**METROPOLITAN GOVERNMENT OF NASHVILLE AND DAVIDSON COUNTY**

**STAFF RECOMMENDATION**  
**1625 Fatherland Street**  
**November 19, 2014**

**Application:** New construction – addition; Setback determination  
**District:** Lockeland Springs-East End Neighborhood Conservation Zoning Overlay  
**Council District:** 06  
**Map and Parcel Number:** 08314011600  
**Applicant:** Thomas C. Smith, Owner  
**Project Lead:** Sean Alexander, sean.alexander@nashville.gov

**Preliminary FLOOR PLAN B**

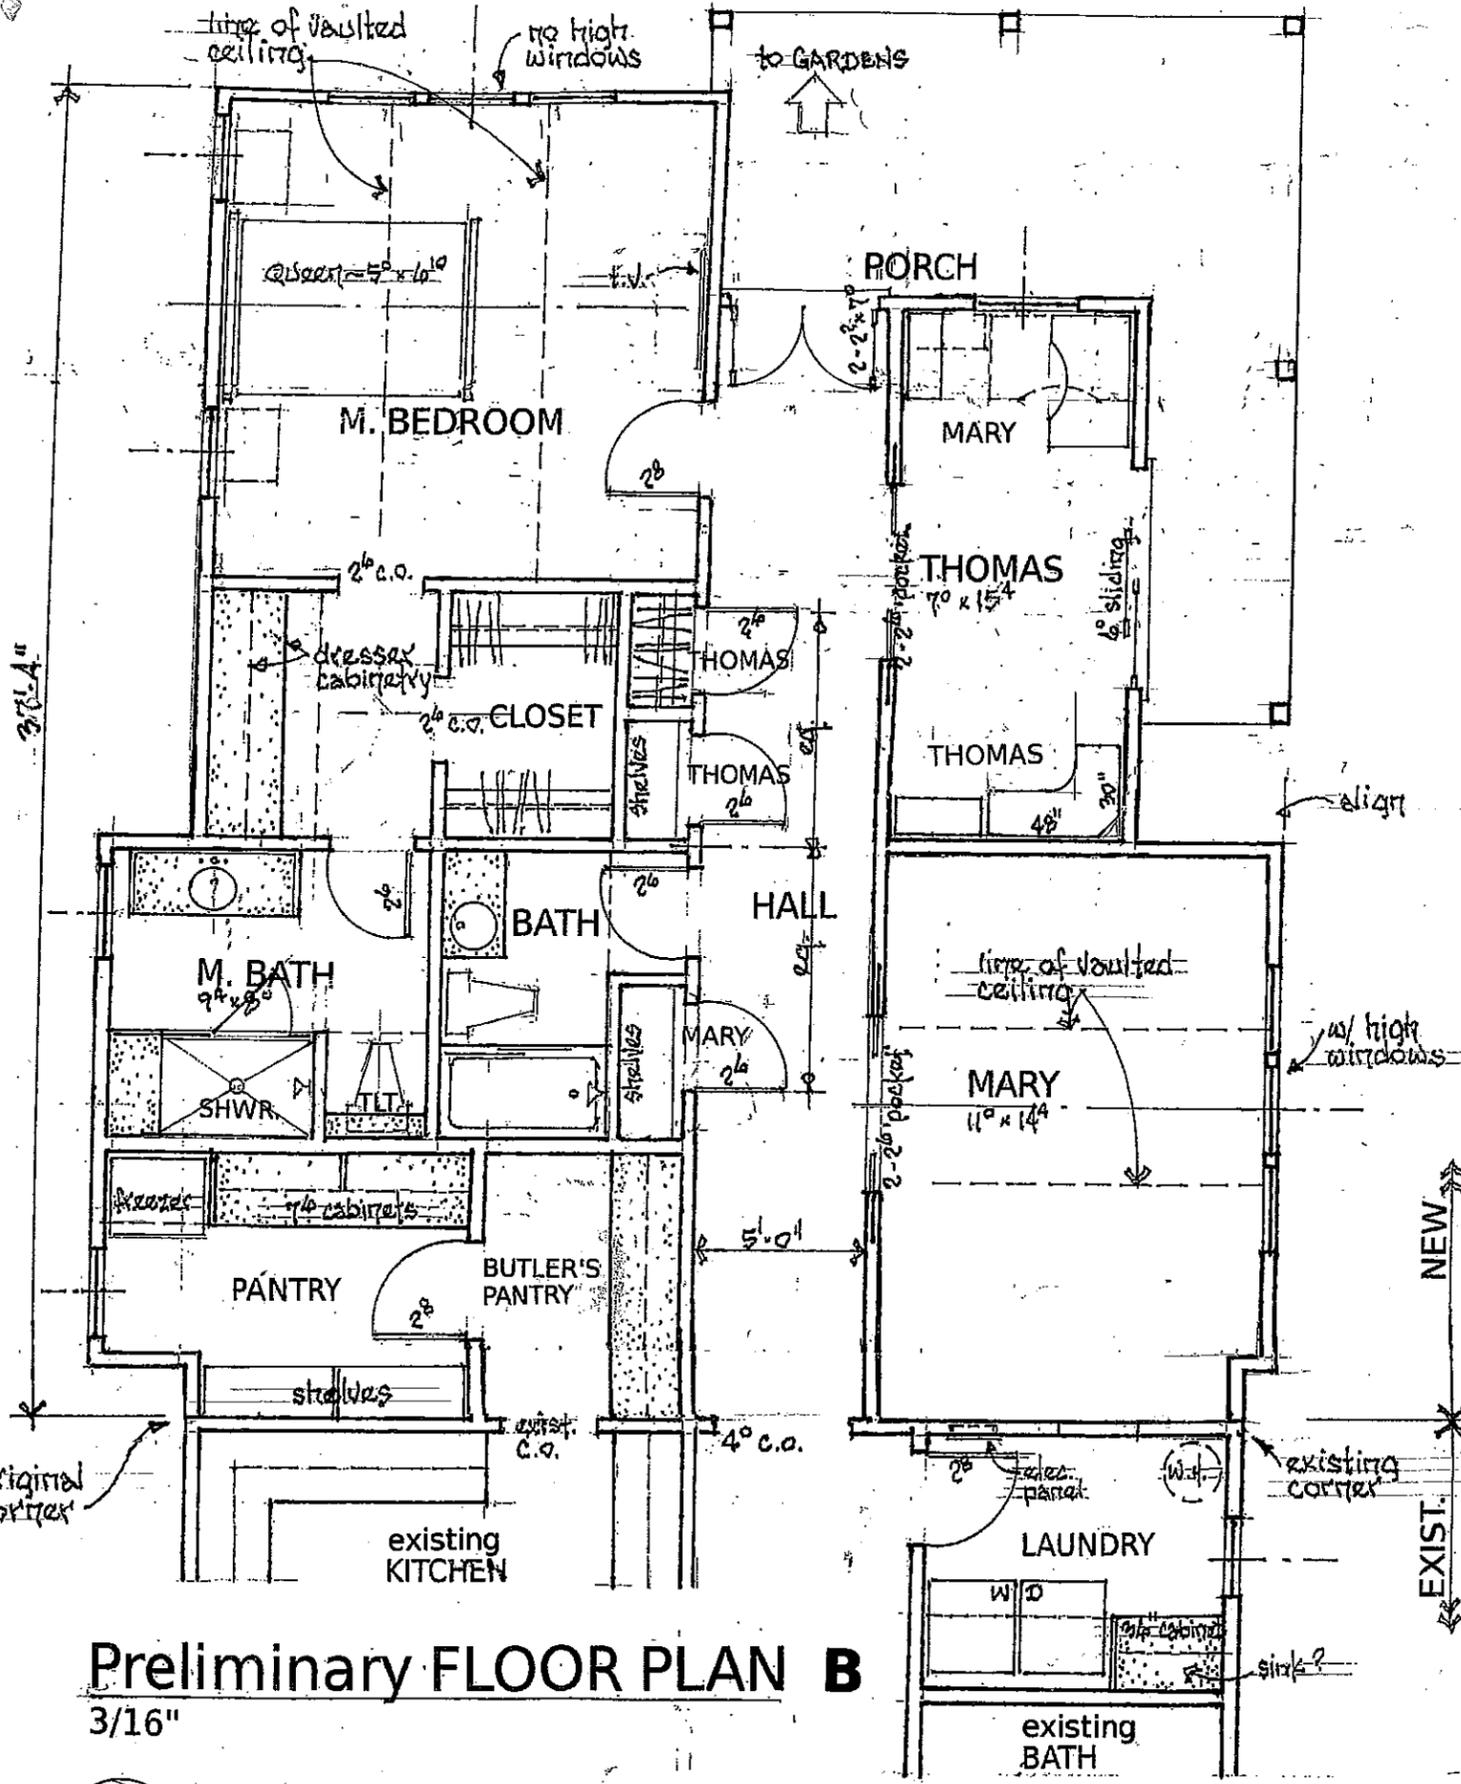
Location & Removability: The addition would tie into the rear of the existing building in line with the side walls of the original structure. Typically, additions are required to sit in at least one foot from the sides of an historic house in order to distinguish the old construction from the new, in order to preserve and minimize the destruction of original features, and to make it possible for the addition to be removed without impairing the essential form and integrity of the historic house. Because the addition does not set in from the sides of the historic house, Staff finds that the project does not meet section II.B.2.

Setback & Rhythm of Spacing: The addition would match the width of the historic house, and would maintain the rhythm of spacing established by the existing houses on the street. The existing house, however, does not meet today's five foot (5') minimum setback requirement on the left side. As such, the addition at four feet, four inches (4'-4") from the property line would not meet the standard setback either. Because it would maintain the setbacks and rhythm established by the historic house, staff finds the setbacks of the proposed addition to be appropriate. The project meets section II.B.3.

- The addition set in from the sides of the historic house by at least one foot (1') on each side;
- Original clapboard siding is not replaced with square batten siding; and,
- Staff approves the window and door selections, and the location of any new HVAC systems prior to issuing a permit.

**REAR ELEVATION**  
3/16"

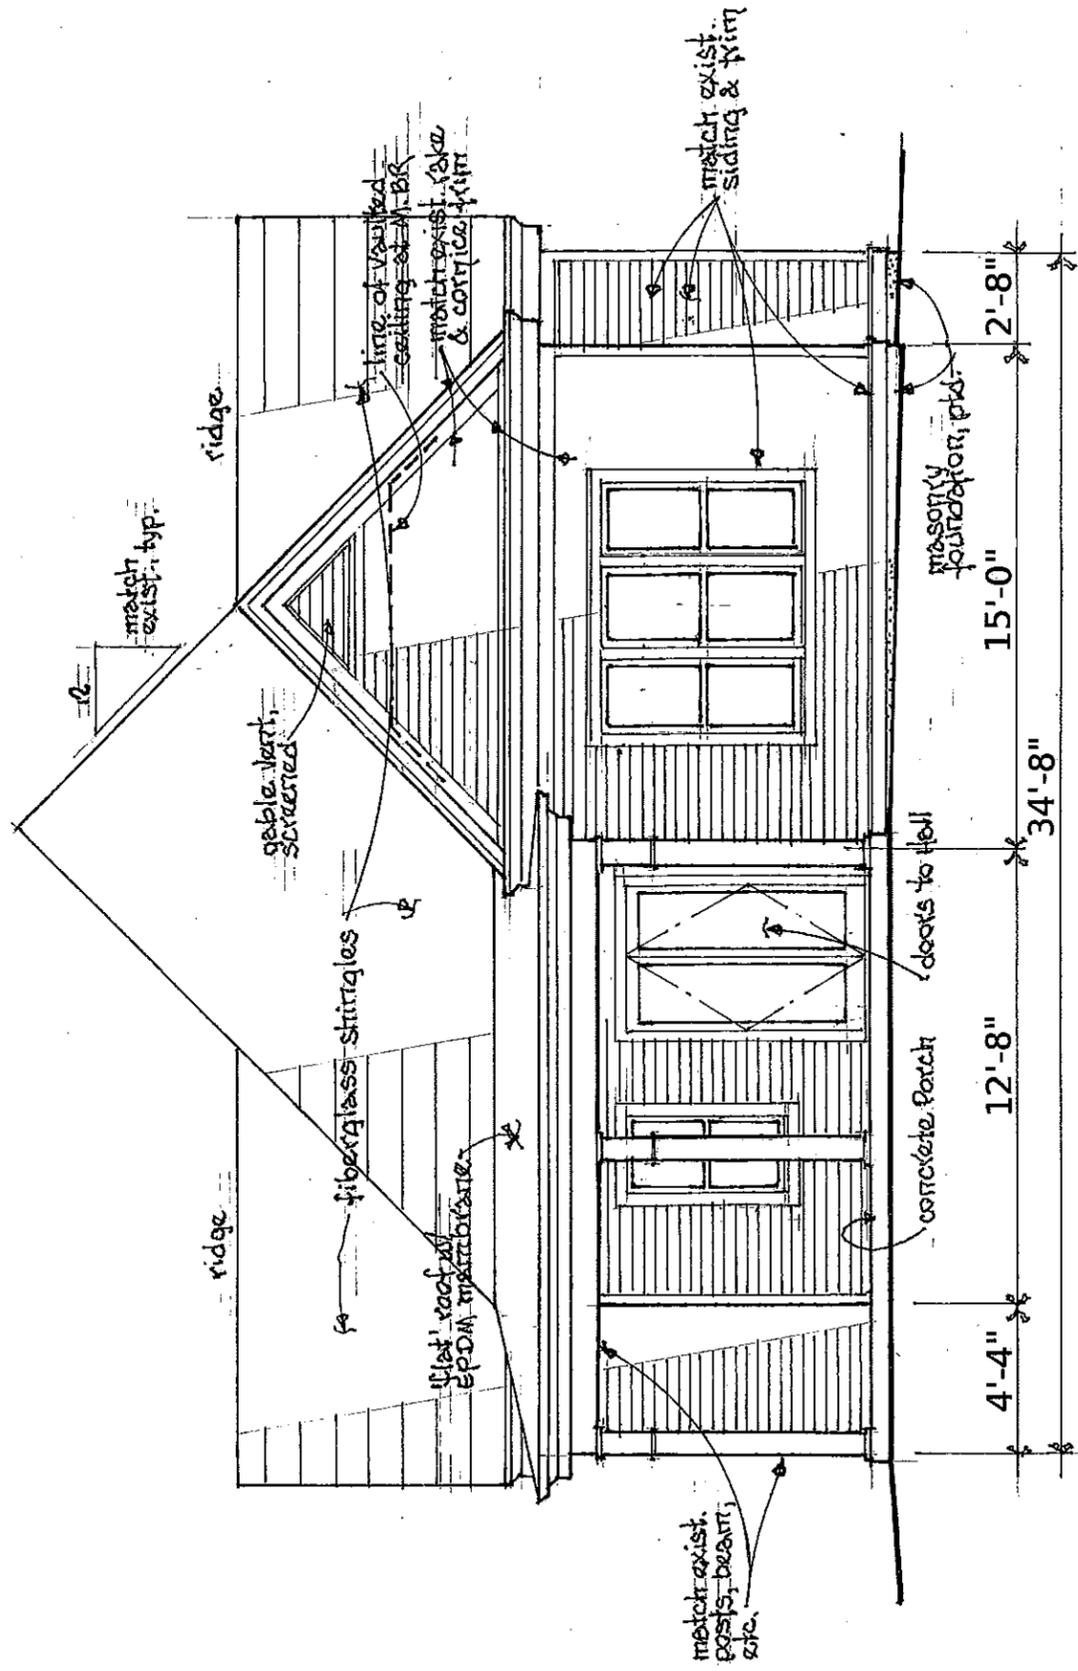
Roof form: The roof of the addition will match the roof of the historic house, with a central hipped component with gable projections on all four sides, matching the 12:12 pitch of the existing roof. The addition will also have a corner porch at the rear, with a low sloped roof matching the porch on the front of the historic house. Staff finds these roofs to be compatible with the historic house. The project meets section II.B.5.

Proportion and Rhythm of Openings: No changes to the window and door openings on the existing house were indicated on the plans. The windows on the proposed addition are all generally twice as tall as they are wide, thereby meeting the historic proportions of openings. There are no large expanses of wall space without a window or door opening. Staff finds the project's proportion and rhythm of openings to meet Section II.B.7.

# RIGHT ELEVATION

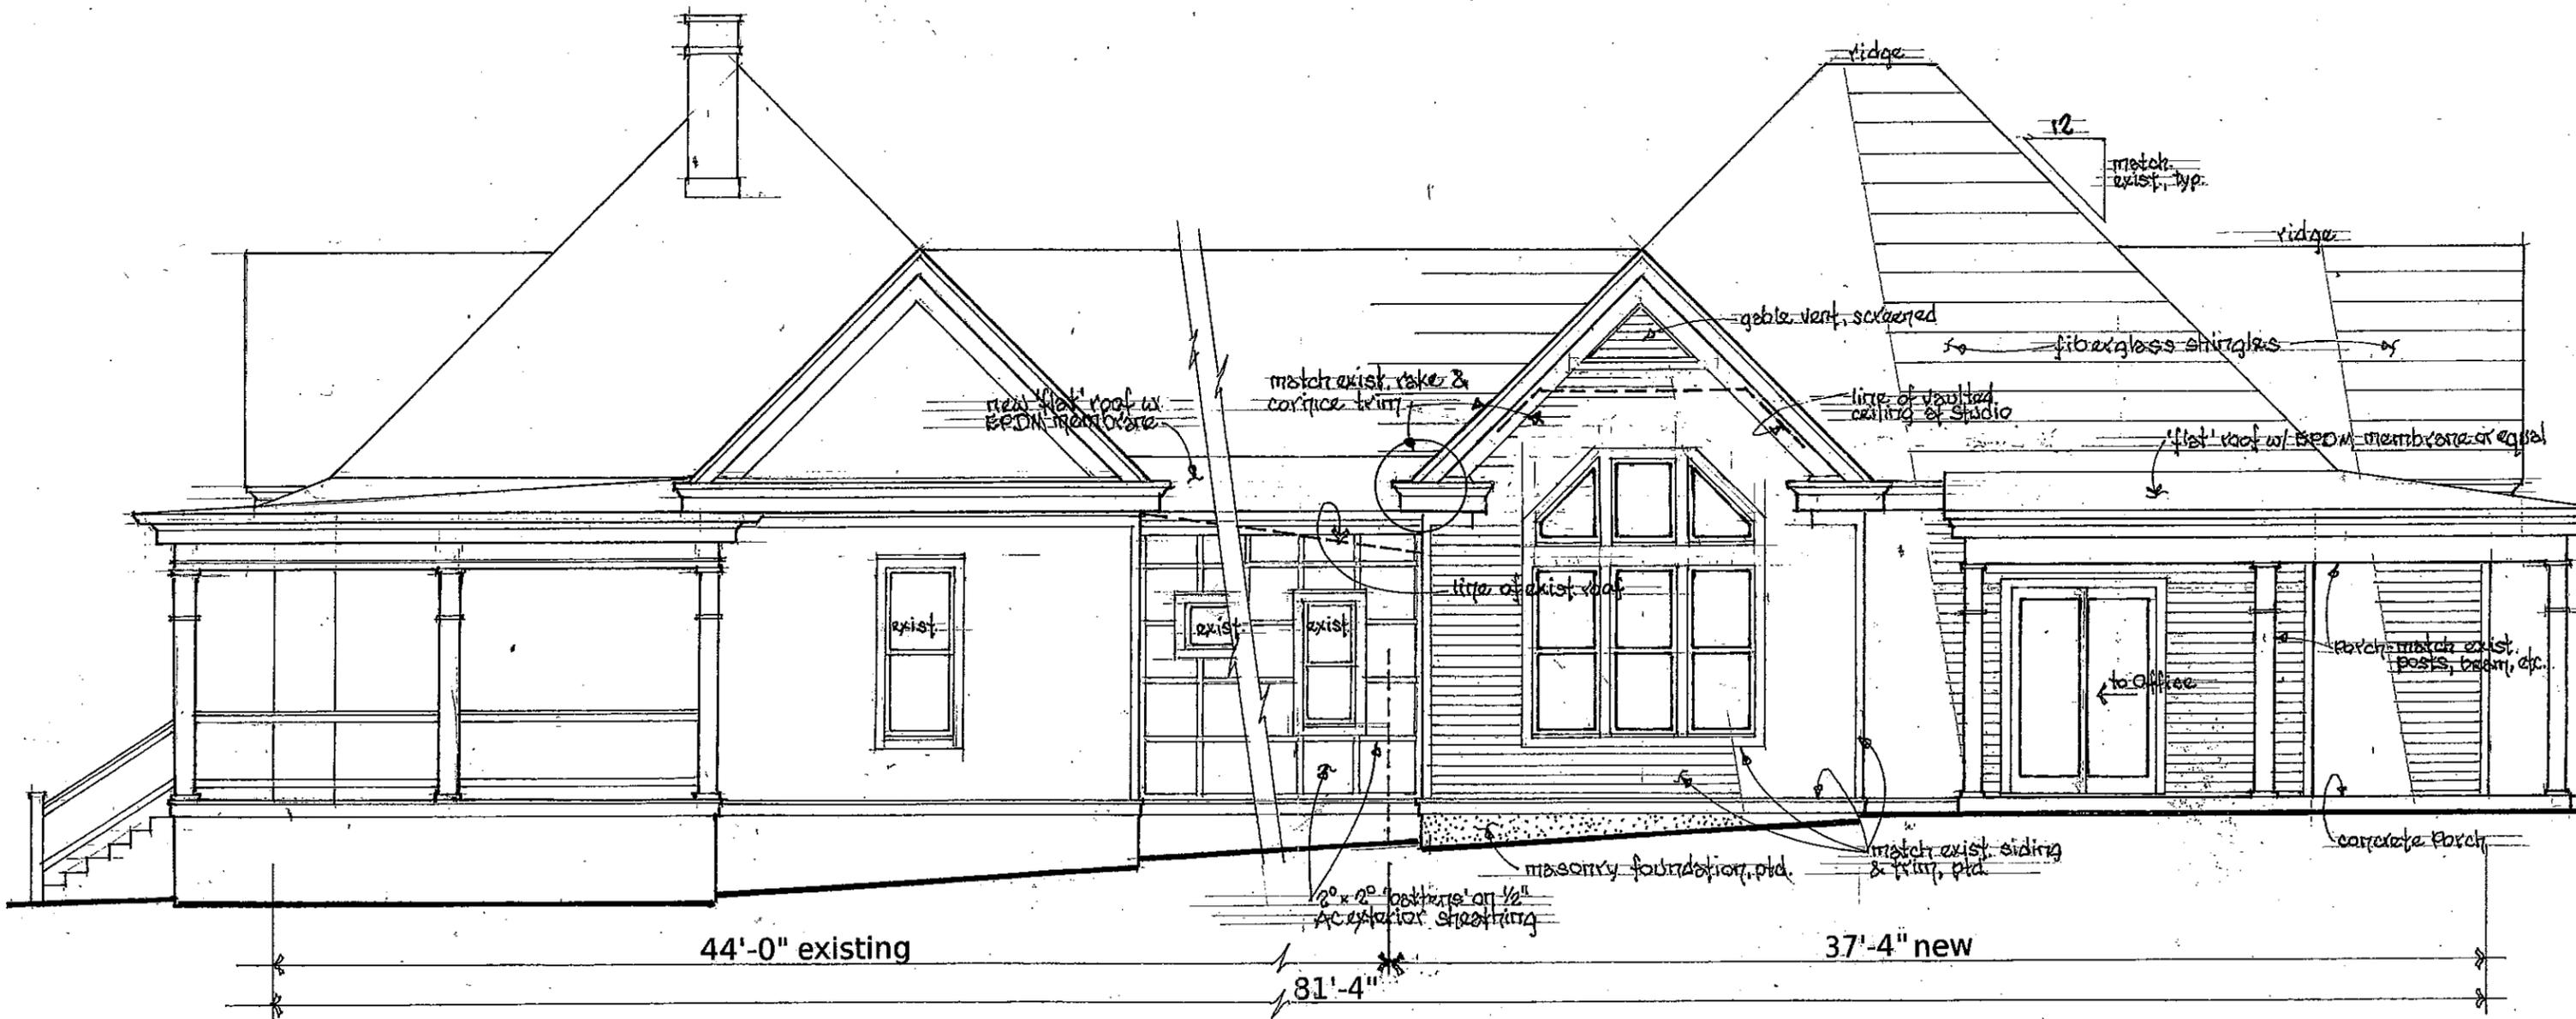
Materials: The exterior materials and colors of the addition will match those of the historic house: wood clapboard siding, wood trim and columns, fiberglass shingle roof, and concrete block foundation. At the point that the addition connects to the existing house, a portion of the original side walls of the house will be resided, replacing original clapboard with a square batten patterned siding. Staff finds that this siding treatment is not appropriate as it destroys original features and alters the character of an original portion of the building. Rear porch posts will be wood and the porch floor will be concrete.
